**Amendments to the Code of Practice for Fire Safety in Buildings 2011 (October 2015 Version)**  
**(June 2023)**

# Corrigenda to the Code of Practice for Fire Safety in Buildings 2011 (FS Code) (June 2023)

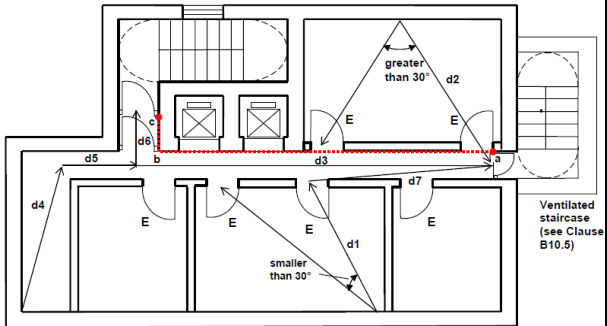
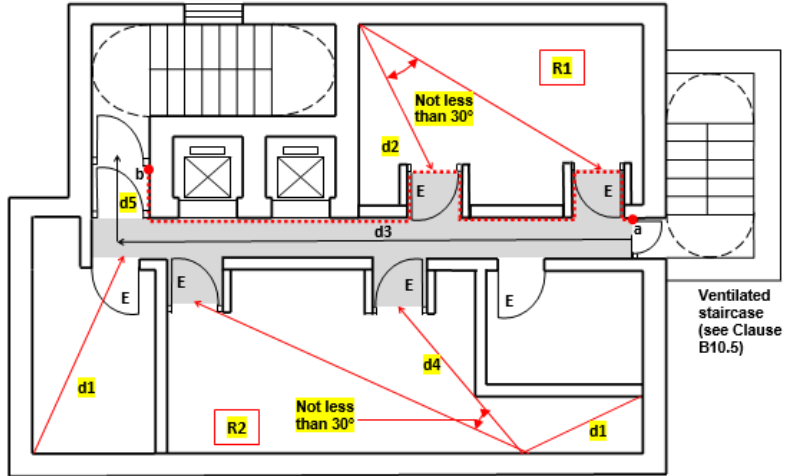
Item	Paragraph/ Table	October 2015 version	Amendments
10.	Diagram B2: Internal Corridor Access	--	<p><b>Example (a): Travel distance requirements for Use Classifications 1 and 2</b></p>  <p><b>Notes:</b></p> <p> Protected corridor</p> <p>E Exit door with required FRR See Clause C7.4</p> <p>d1+d2 Deadend travel distance d1: Max. 24m, see Clauses B11.2(a)(i) and B11.7 d2: Max. 15m, see Clauses B11.2(a)(ii) and B11.7</p> <p>d3 Maximum travel distance Max. 24m, see Clause B11.3(a)(i)</p> <p>d4 + d5 Maximum separation between 2 required staircases Max. 48m, see Clause B11.3(b) (Applicable to all Use Classifications)</p> <p>a ••••• b or d4+ d5 whichever the less Minimum separation between 2 required staircases Min. 6m, see Clause B10.2(b) (Applicable to all Use Classifications)</p>

Item	Paragraph/ Table	October 2015 version	Amendments
		 <p>Notes:</p> <p>E Exit door</p> <p>d4 + d5 Deadend travel distance See Clause B11.2</p> <p>d1 Deadend travel distance See Clause B11.2</p> <p>a - b - c Minimum separation between 2 required staircases See Clause B10.2(b)</p> <p>d3 + d6 Maximum separation between 2 required staircases See Clause B11.3(b)</p> <p>d2 Travel distance See Clause B11.3(a)</p> <p>d1 + d7 Travel distance See Clause B11.3(a)</p>	<p><b>Example (b):</b> <b>Travel distance requirements for Use Classifications 3 to 8</b></p>  <p>Notes:</p> <p>Protected corridor</p> <p>E Exit door with required FRR See Clause C7.4</p> <p>d1 Deadend travel distance See Clauses B11.2(b)(i) &amp; (c)(i), and B11.7</p> <p>d2 Maximum travel distance See Clauses B11.3(a)(ii) &amp; (iii), B11.6 and B11.7</p> <p>d1 + d4 in R2 Maximum travel distance See Clauses B11.3(a)(ii) &amp; (iii), B11.6 and B11.7</p> <p>d3 + d5 Maximum separation between 2 required staircases Max. 48m, see Clause B11.3(b) (Applicable to all Use Classifications)</p> <p>a - b or d3 + d5 whichever the less Minimum separation between 2 required staircases Min. 6m, see Clause B10.2(b) (Applicable to all Use Classifications)</p> <p>R1 and R2 Rooms required to be provided with 2 exit doors See Clause B11.6</p>

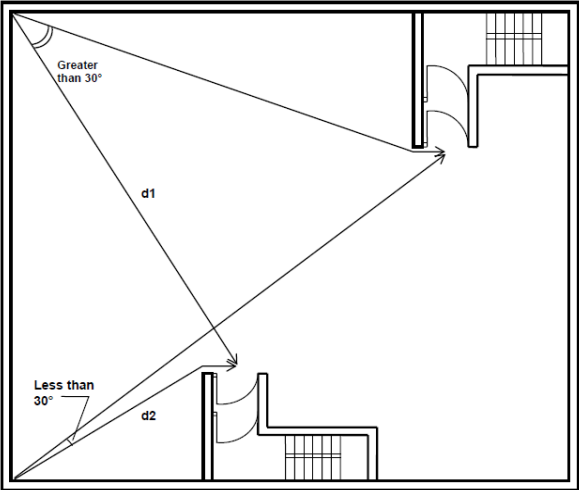
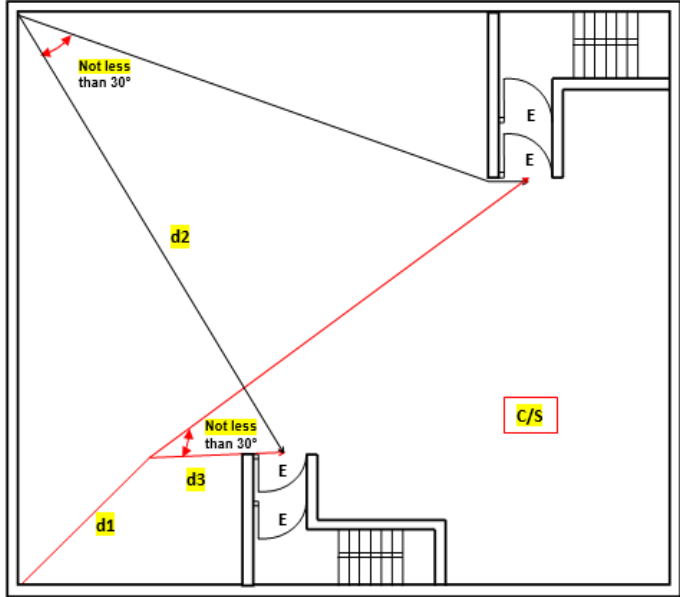
Item	Paragraph/ Table	October 2015 version	Amendments
11.	Diagram B3: Open Plan Layout	 <p>Notes:</p> <p>d1      Travel distance based on two exits being available</p> <p>d2      Deadend travel distance</p>	<p><b>Diagram B3: Open Plan Layout for Use Classifications 3 to 8</b></p>  <p>Notes:</p> <p>E      Exit door with required FRR      See Clause B10.4(b)</p> <p>d1      Deadend travel distance      See Clauses B11.2(b)(i) &amp; (c)(i) and B11.7</p> <p>d2      Travel distance based on two exits being available      See Clauses B11.3(a)(ii)&amp;(iii), B11.6 and B11.7</p> <p>d1 + d3      Travel distance based on a point of choice being available      See Clauses B11.3(a)(ii)&amp;(iii) B11.6 and B11.7</p> <p>C/S      Fire compartment or storey required to be provided with 2 exit doors      See Clause B11.6(b)</p>

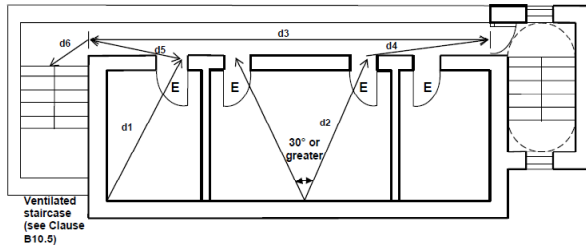
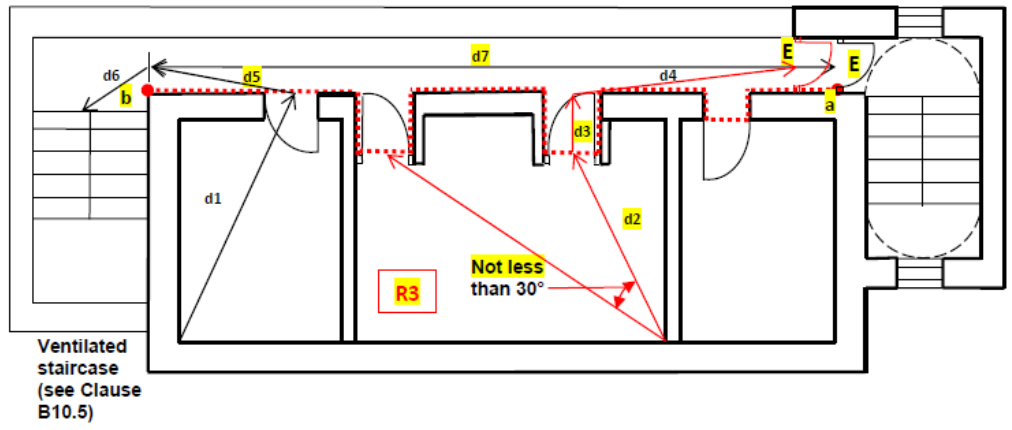
Item	Paragraph/ Table	October 2015 version	Amendments																																							
12.	Diagram B4: Balcony Approach	<div></div> <p>Ventilated staircase (see Clause B10.5)</p> <p>Notes:</p> <table><tr><td>E</td><td>Exit door</td><td></td></tr><tr><td>d1</td><td>Deadend travel distance</td><td>See Clause B11.2</td></tr><tr><td>d2 + d4</td><td>Travel distance</td><td>See Clause B11.3(a)</td></tr><tr><td>d1 + d5 + d6</td><td>Travel distance</td><td>See Clauses B11.2 &amp; B11.3(a)</td></tr><tr><td>d3</td><td>Maximum separation between 2 required staircases</td><td>See Clause B11.3(b)</td></tr></table>	E	Exit door		d1	Deadend travel distance	See Clause B11.2	d2 + d4	Travel distance	See Clause B11.3(a)	d1 + d5 + d6	Travel distance	See Clauses B11.2 & B11.3(a)	d3	Maximum separation between 2 required staircases	See Clause B11.3(b)	<div></div> <p>Ventilated staircase (see Clause B10.5)</p> <p>Notes:</p> <table><tr><td>E</td><td>Exit door with required FRR</td><td>See Clause B10.4(b)</td></tr><tr><td>d1</td><td>Deadend travel distance</td><td>See Clauses B11.2 and B11.7</td></tr><tr><td>d2 + d3 + d4</td><td>Maximum travel distance (Not applicable to Use Classifications 1 &amp; 2)</td><td>Max. 45m, see Clauses B11.3(a)(ii)&amp;(iii), B11.6 and B11.7</td></tr><tr><td>d1 + d5 + d6</td><td>Maximum travel distance (Not applicable to Use Classifications 1 &amp; 2)</td><td>Max. 45m, see Clauses B11.3(a)(ii)&amp;(iii), B11.6 and B11.7</td></tr><tr><td>d5 + d6</td><td>Maximum travel distance (Applicable to Use Classifications 1 &amp; 2)</td><td>Max. 45m, see Clauses B11.3(a)(i), B11.6 and B11.7</td></tr><tr><td>d7</td><td>Maximum separation between 2 required staircases</td><td>Max. 48m, see Clause B11.3(b)</td></tr><tr><td>a or d7 whichever the less</td><td>Minimum separation between 2 required staircases</td><td>Min. 6m, see Clause B10.2(b)</td></tr><tr><td>R3</td><td>Room required to be provided with 2 exit doors</td><td>See Clause B11.6</td></tr></table>	E	Exit door with required FRR	See Clause B10.4(b)	d1	Deadend travel distance	See Clauses B11.2 and B11.7	d2 + d3 + d4	Maximum travel distance (Not applicable to Use Classifications 1 & 2)	Max. 45m, see Clauses B11.3(a)(ii)&(iii), B11.6 and B11.7	d1 + d5 + d6	Maximum travel distance (Not applicable to Use Classifications 1 & 2)	Max. 45m, see Clauses B11.3(a)(ii)&(iii), B11.6 and B11.7	d5 + d6	Maximum travel distance (Applicable to Use Classifications 1 & 2)	Max. 45m, see Clauses B11.3(a)(i), B11.6 and B11.7	d7	Maximum separation between 2 required staircases	Max. 48m, see Clause B11.3(b)	a or d7 whichever the less	Minimum separation between 2 required staircases	Min. 6m, see Clause B10.2(b)	R3	Room required to be provided with 2 exit doors	See Clause B11.6

E	Exit door																																									
d1	Deadend travel distance	See Clause B11.2																																								
d2 + d4	Travel distance	See Clause B11.3(a)																																								
d1 + d5 + d6	Travel distance	See Clauses B11.2 & B11.3(a)																																								
d3	Maximum separation between 2 required staircases	See Clause B11.3(b)																																								
E	Exit door with required FRR	See Clause B10.4(b)																																								
d1	Deadend travel distance	See Clauses B11.2 and B11.7																																								
d2 + d3 + d4	Maximum travel distance (Not applicable to Use Classifications 1 & 2)	Max. 45m, see Clauses B11.3(a)(ii)&(iii), B11.6 and B11.7																																								
d1 + d5 + d6	Maximum travel distance (Not applicable to Use Classifications 1 & 2)	Max. 45m, see Clauses B11.3(a)(ii)&(iii), B11.6 and B11.7

d5 + d6	Maximum travel distance (Applicable to Use Classifications 1 & 2)	Max. 45m, see Clauses B11.3(a)(i), B11.6 and B11.7																																								
d7	Maximum separation between 2 required staircases	Max. 48m, see Clause B11.3(b)																																								
a or d7 whichever the less	Minimum separation between 2 required staircases	Min. 6m, see Clause B10.2(b)																																								
R3	Room required to be provided with 2 exit doors	See Clause B11.6
